**Report: REMARKS**  
**Function: Test, Adjust, & Balance**  
**Date: 03/05/2026**  
**Completed By: National TAB**

**PROJECT**  
**03-02-26 CULVERS - MESA, AZ**

## Issue List

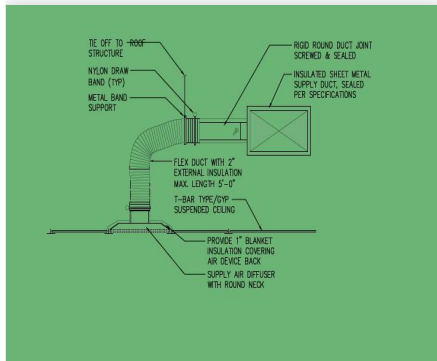
**Issue Name :** NONFUNCTIONAL DAMPER  
**Description :** SGRD1-7: Flow varies between 345-380cfm regardless of lever movement (DR)  
**Created By :** National TAB                      **Assigned To :** National TAB - Brianna Biggs  
**Status :** Open  
**Priority :** Urgent                                      **Asset Tag :** SGRD7  
**Originated Date :** 03/06/2026 - Christine Weale - National TAB
